ADDENDUM NUMBER 2

1.01 DATE: MARCH 19, 2021

1.02 PROJECT: WILLIAM HOOPER COUNCILL MEMORIAL

1.03 PROJECT NUMBER: B. C. NO. 2021152

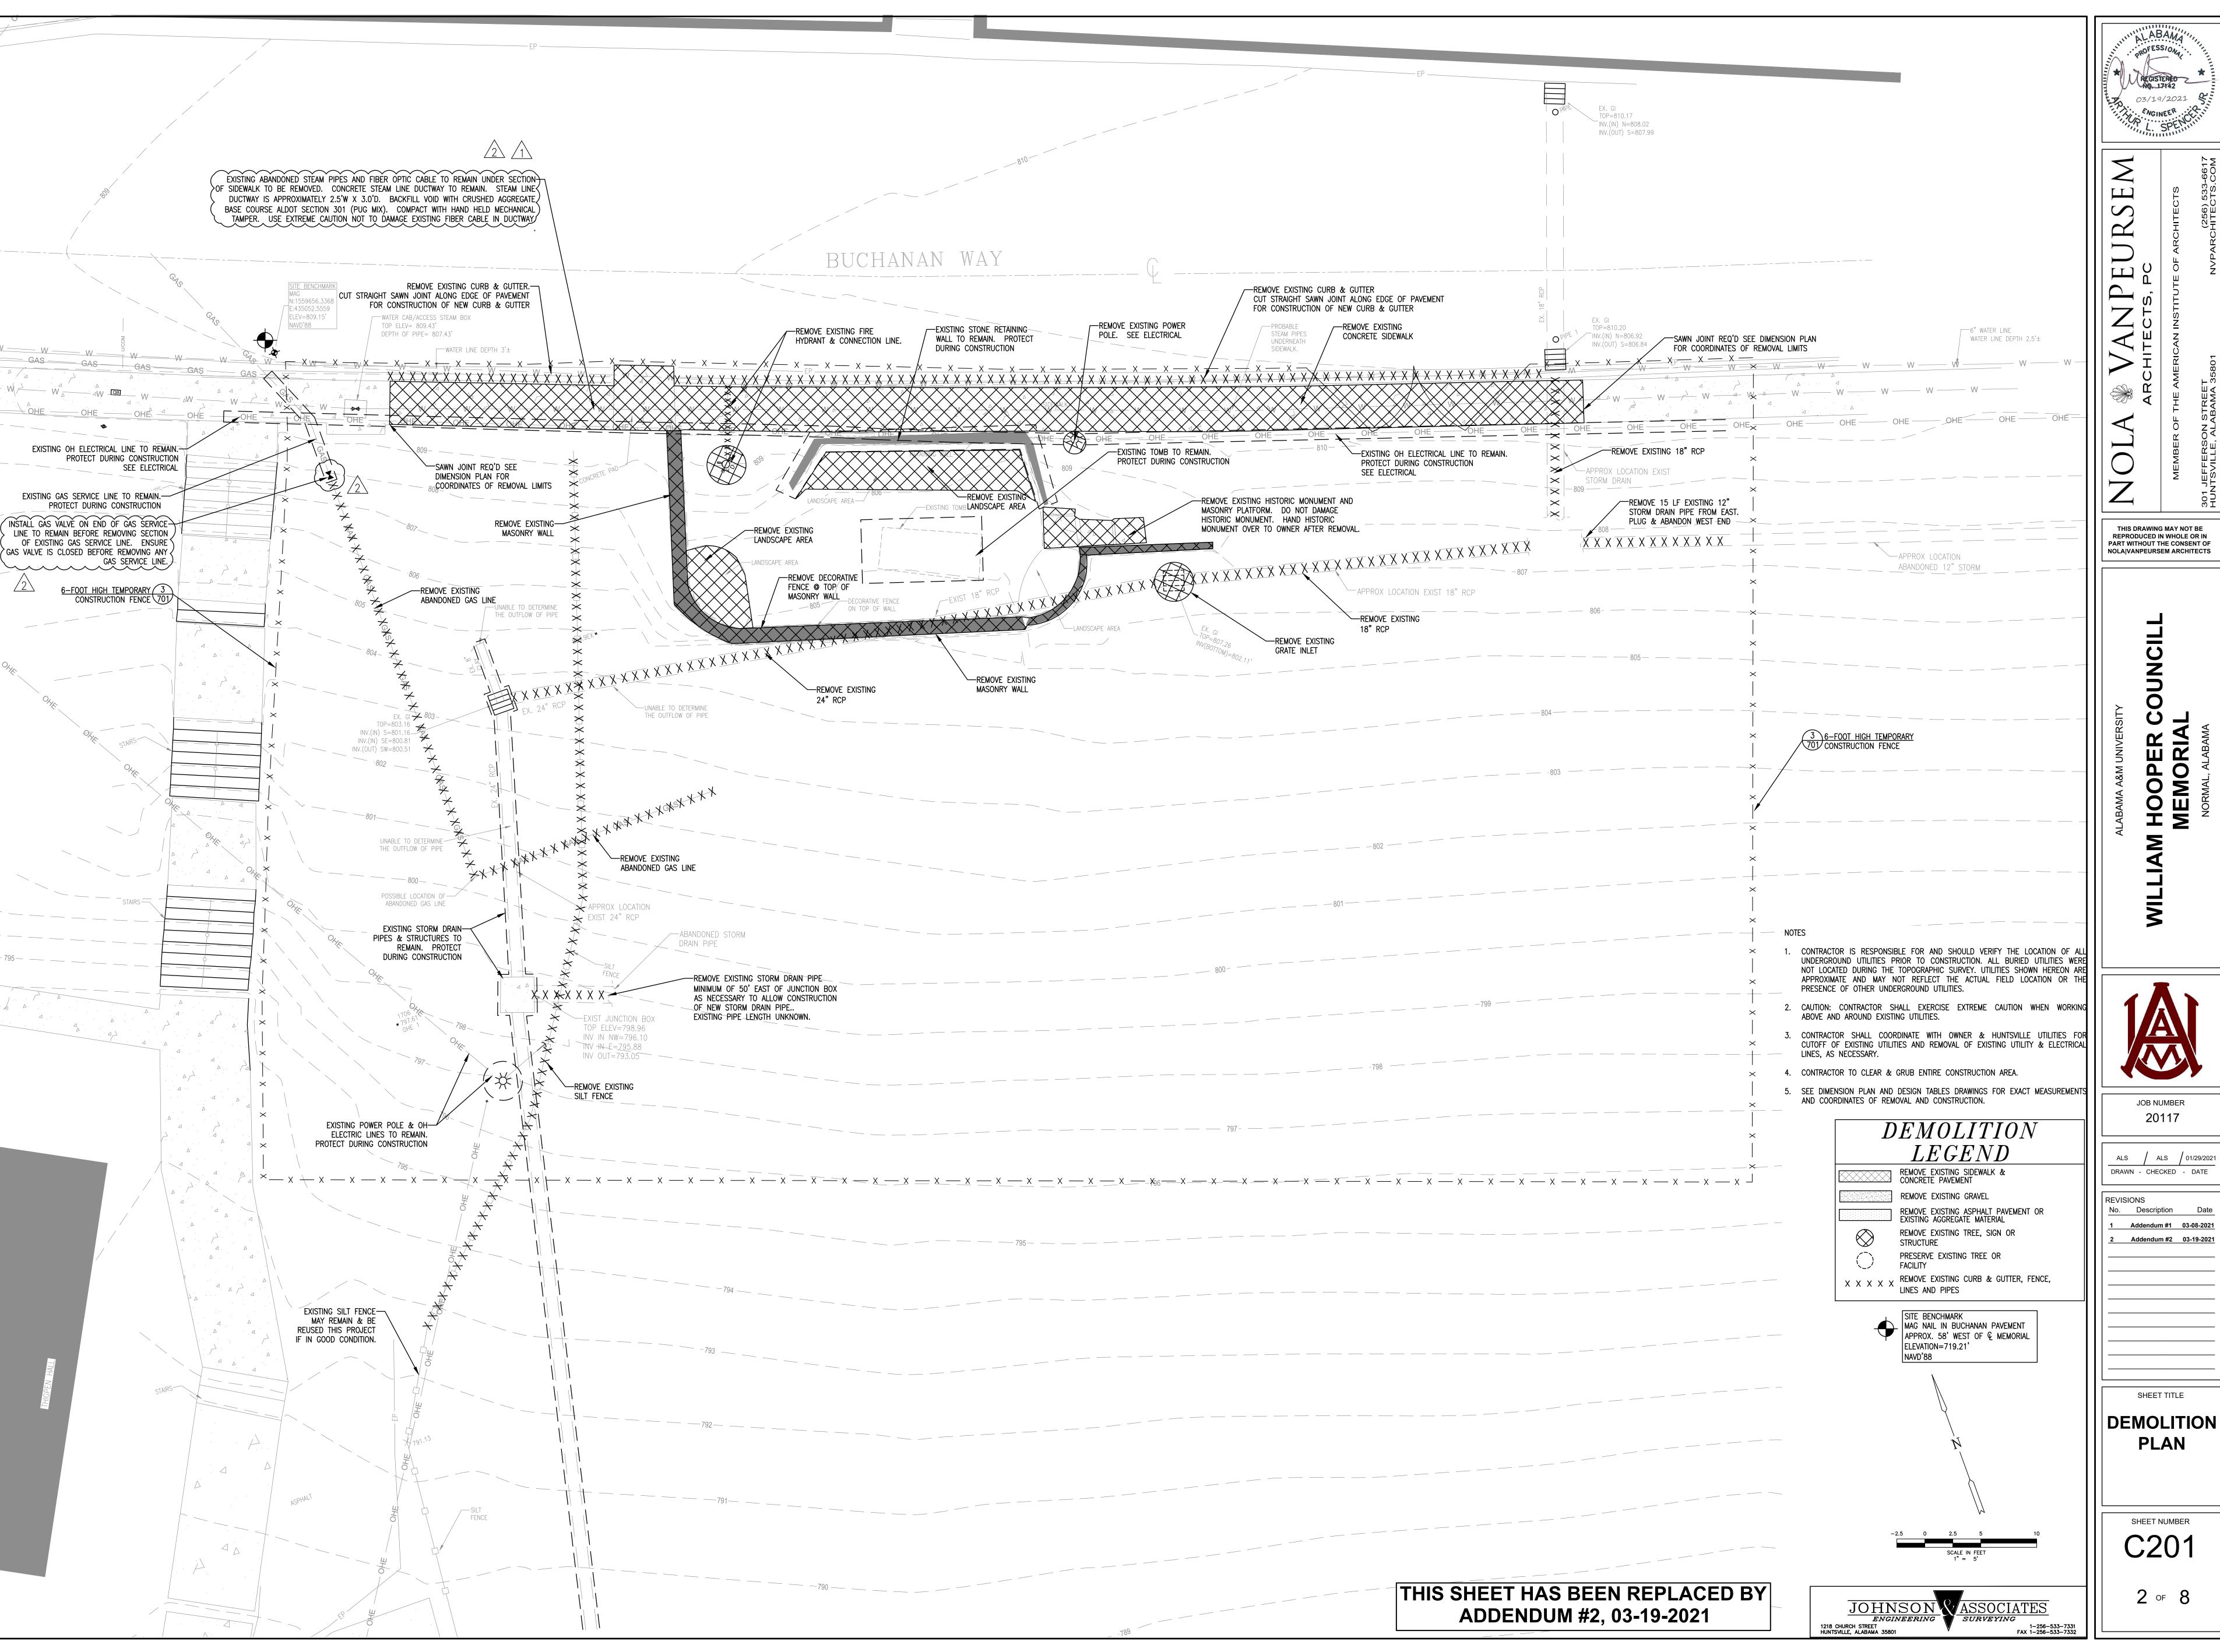
4.01 SHEET C201 - DEMOLITION PLAN:

- A. Replace this sheet in its entirety. Revisions include the following:
 - 1. Changed steam pipe removal note to say that existing abandoned steam pipes and fiber optic cable are to remain.
 - 2. Added gas valve and note that gas valve is to be installed at end of the "to remain" section of the existing gas service line. The new gas valve must be closed before any gas service line is removed.

4.02 SHEET A-1.1 - PERGOLA PLAN & DETAILS:

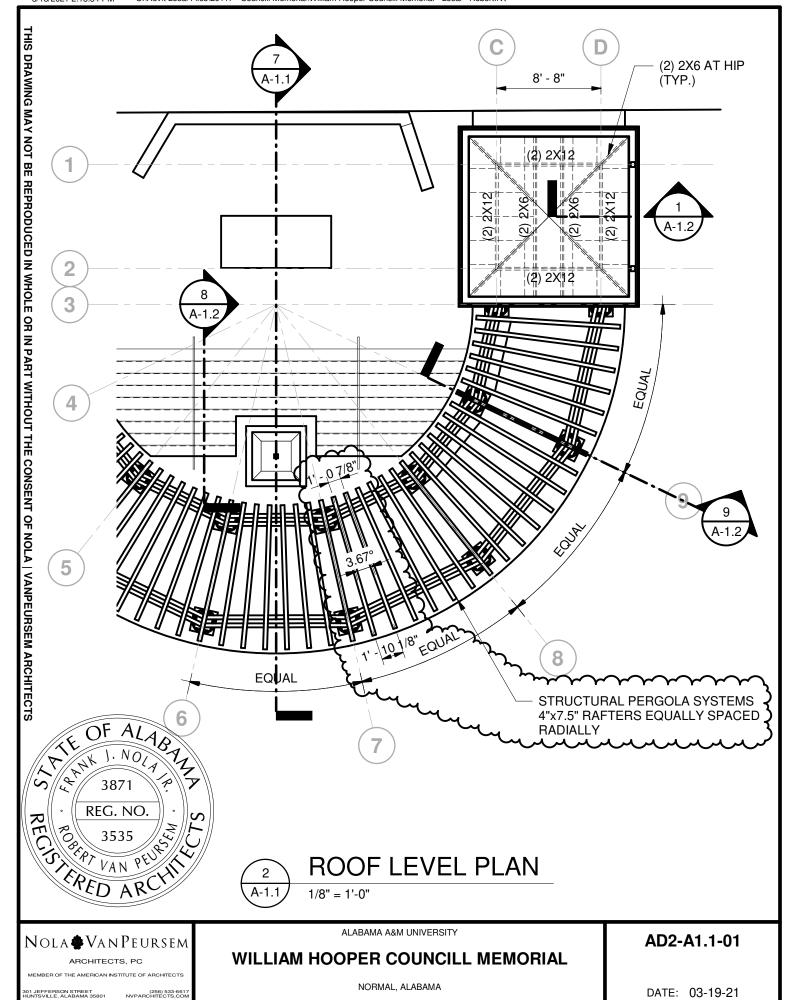
- A. 1/A-1.1 Ground Level Plan: Remove utility pole per attachment AD2-A1.1-02.
- B. 2/A-1.1 Roof Level Plan: Add rafter spacing per attachment AD2-A1.1-02.
- C. 9/A1.1 Typical Guardrail Elevation & Section: Add the following note: From the outside edge of concrete slab to the center of guardrail is approximately 6-inches.
- D. Add General Sod Notes to read:
 - 1. Provide 200 sq. vd. of Bermuda 419 Sod.
 - 2. The acidity range for topsoil to be placed in areas to receive sod shall be 6.0 7.0. The mechanical analysis of the soil shall be as follows:

4.03 SHEET A-1.2 - PERGOLA DETAILS:

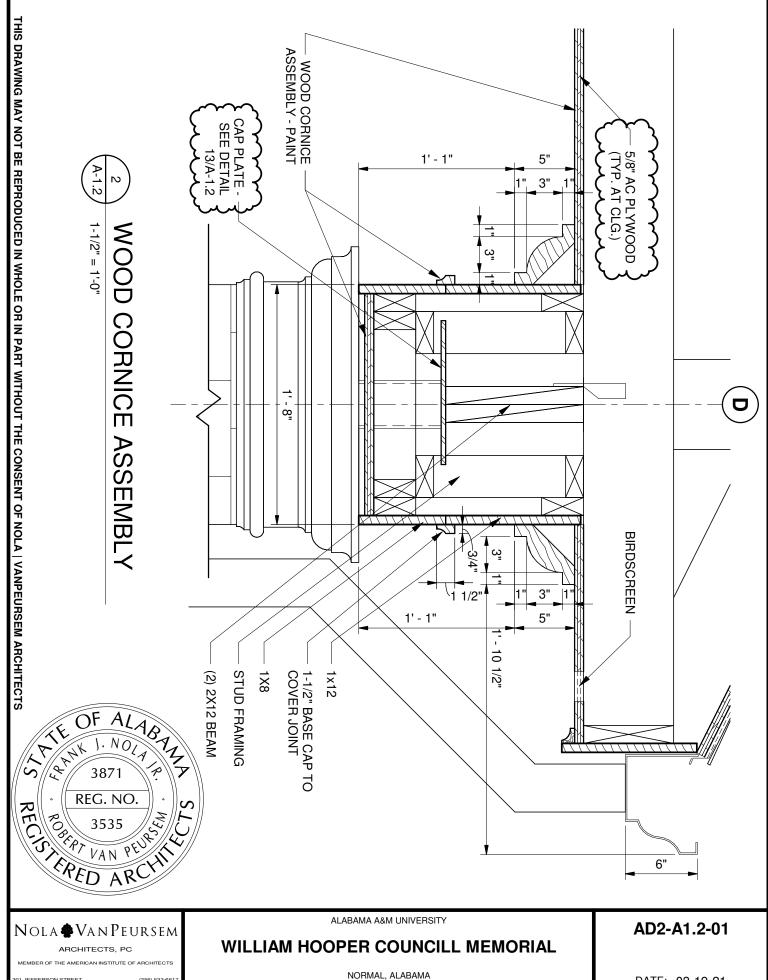
- A. 1/A1.2 Wall Section: Add the following note: Provide 24"X12" bump-out wall under steel columns at pavilion. Reinforce 24"x24" area of wall under steel column with #5 bar in each cell.
- B. 2/A-1.2 Wood Cornice Assembly: Add notes for plywood and cap plate per attachment AD2-A1.2-01.
- C. 9/A-1.2 Pergola Section: Pergola system by Structural Pergola Systems: www.structuralpergolasystems.com or approved equal.
- D. Add Detail 15/A-1.2 Concrete Bench Detail per attachment AD2-A1.2-02.
